**Proposed Rezoning of land and Staged, Multi-lot Subdivision of land.  
City of Greater Geelong Planning Scheme Amendment C372**

**REPORT ON DRAINAGE OUTFALL**

35 AND 69-93 HAMS ROAD, WAURN PONDS

Tomkinson Group Ref: A4073

**ATTACHMENT 2 – Drainage options**

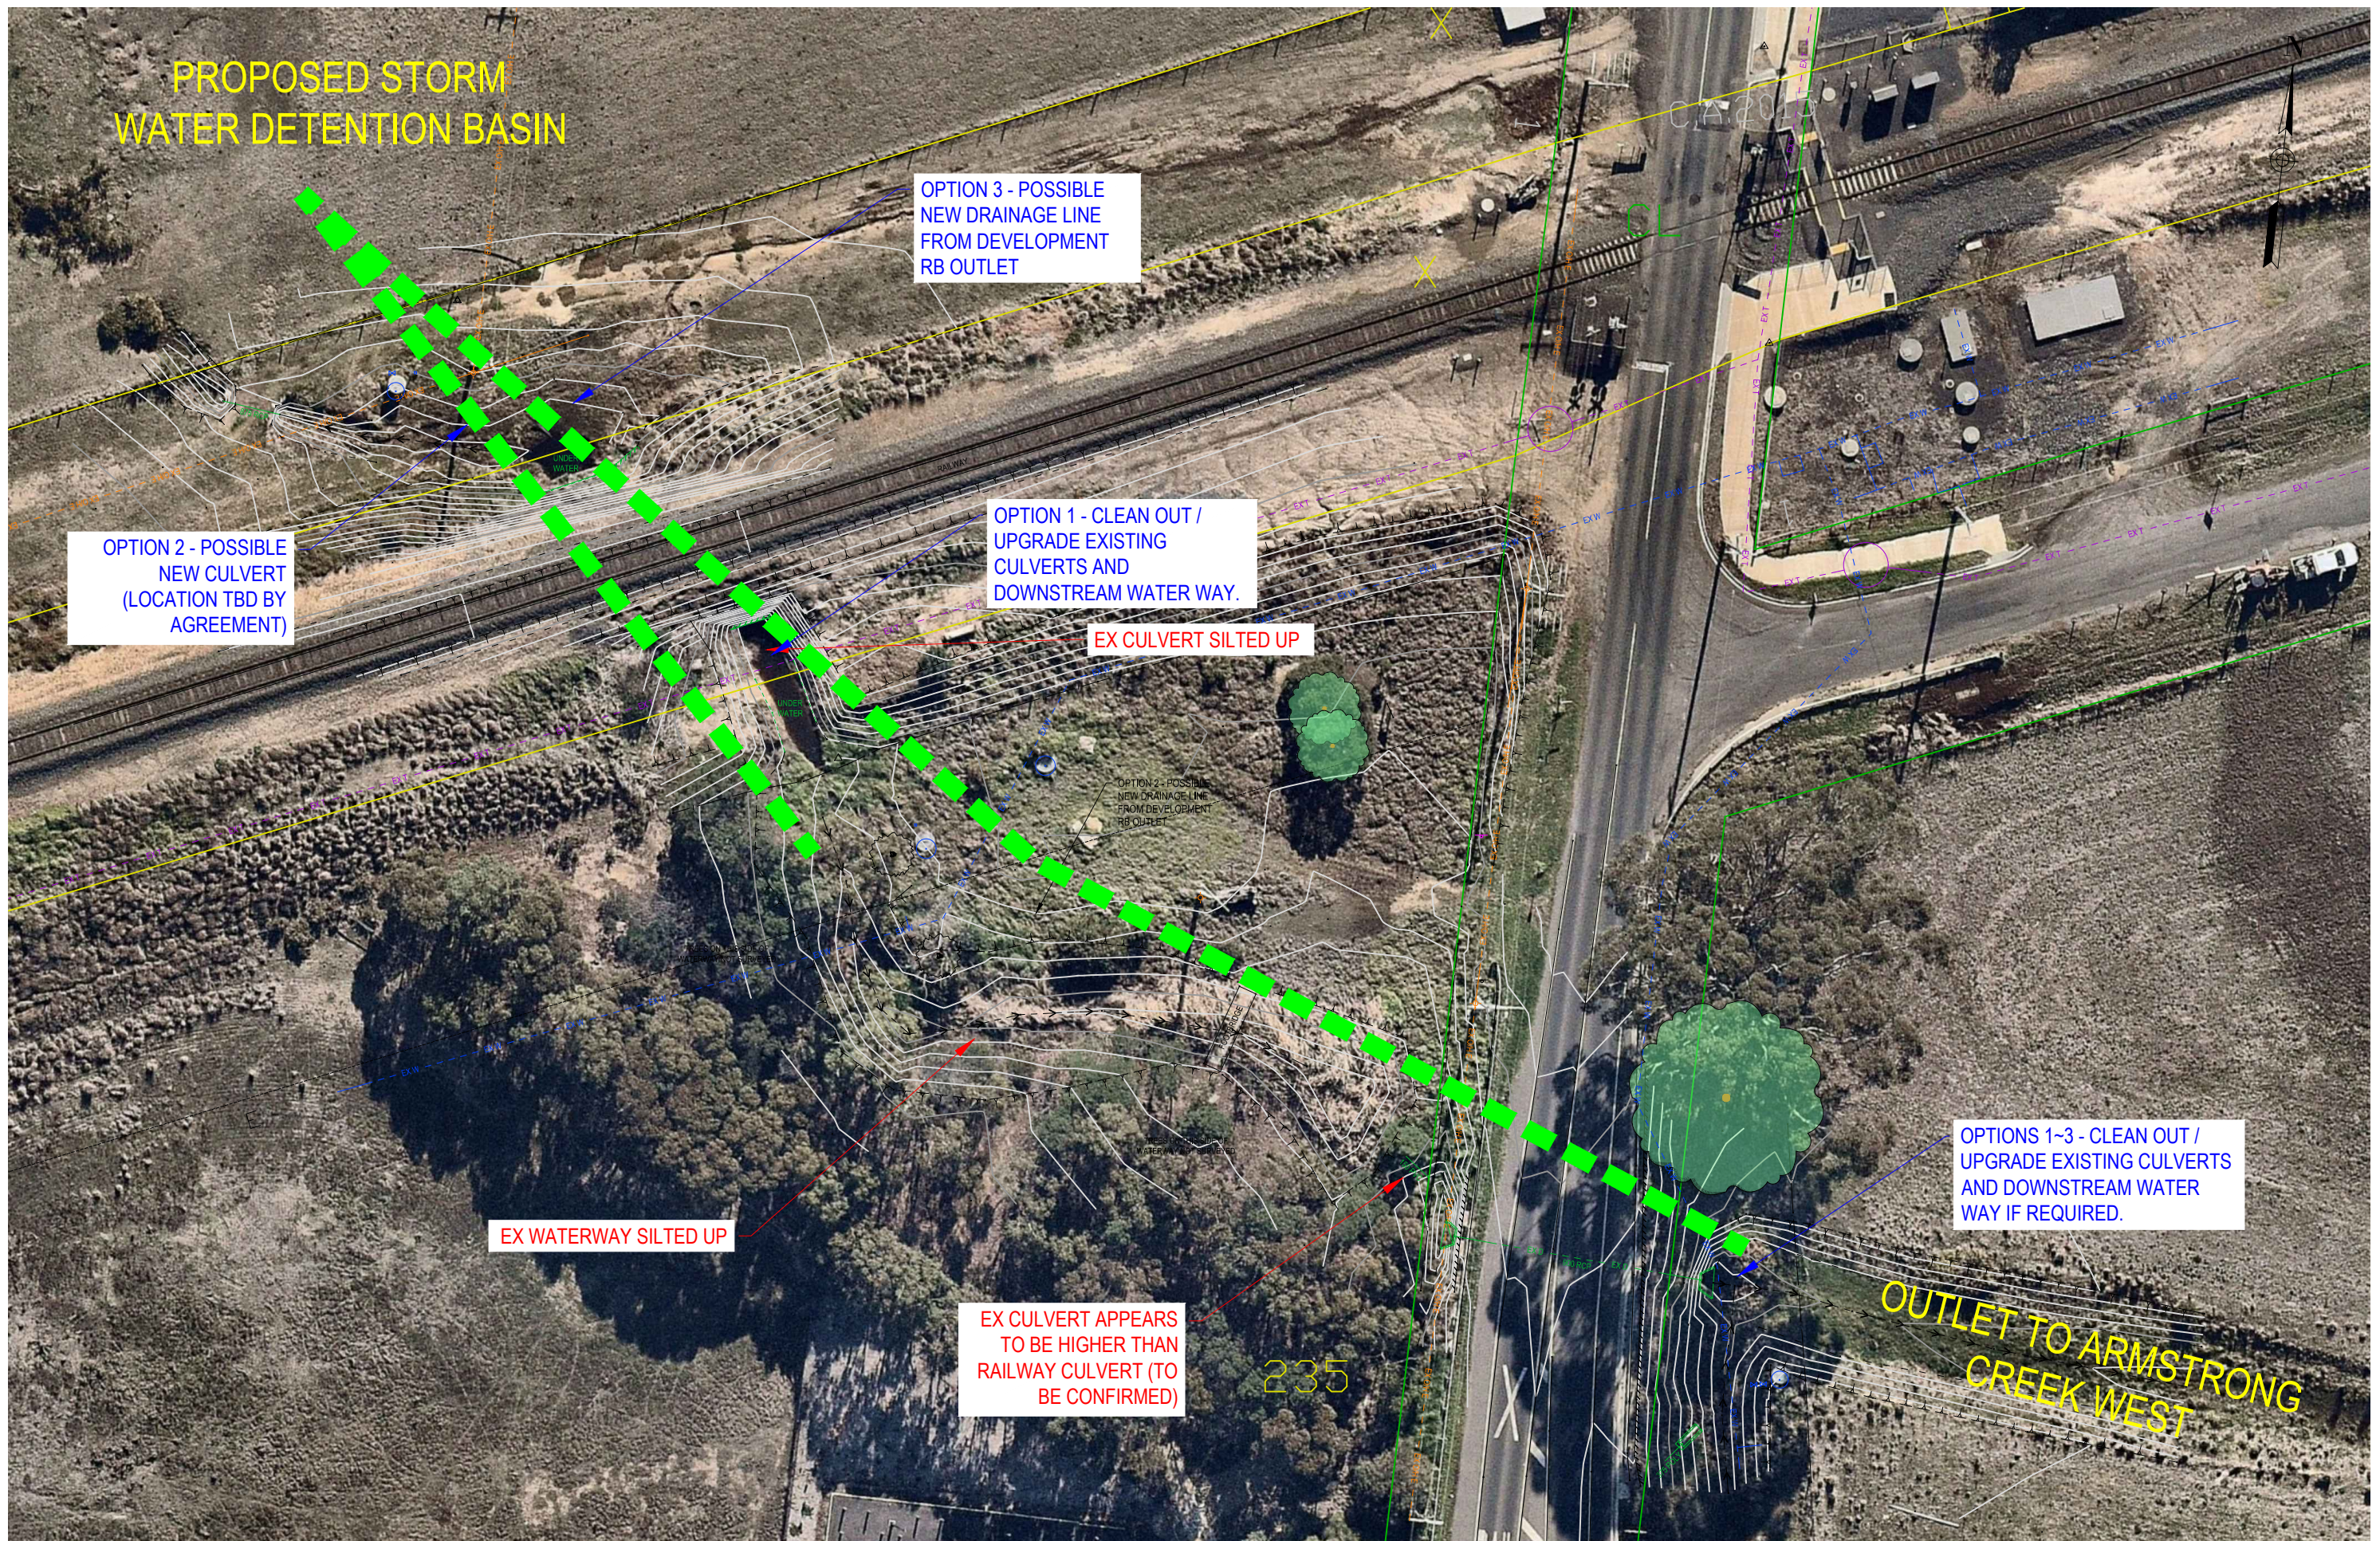
- CI 6.2 requires the owner of the land to be responsible for external drainage works, including but not be limited to: cleaning and upgrading, where necessary, to the Ghazeepore Road culvert and Geelong-Warrnambool railway culvert. This clause allows enough room for a design outcome to be achieved, whilst still satisfying the needs of stakeholders. Discussions with V/Line and Victrack have resulted in three general outcomes being possible (refer attachment 2):

- OPTION 1 – Clean out and / or upgrade existing railway culverts and downstream waterway  
Noting that while this option is not preferred by V/line and VicTrack due to the age of the existing culvert and the fact that any proposed upgrade may not meet current V/line and VicTrack Standards, cleanout and refurbishment of the existing culvert in conjunction with option 2 or 3 may also be possible.

- OPTION 2 – Possible new culvert (location TBD by agreement) under rail line; Clean out and / or upgrade downstream waterway and Ghazeepore Rd culverts (if required)

- OPTION 3 – Possible new drainage line from development basin outlet directly to the downstream waterway (ie bypass existing culverts and waterway).
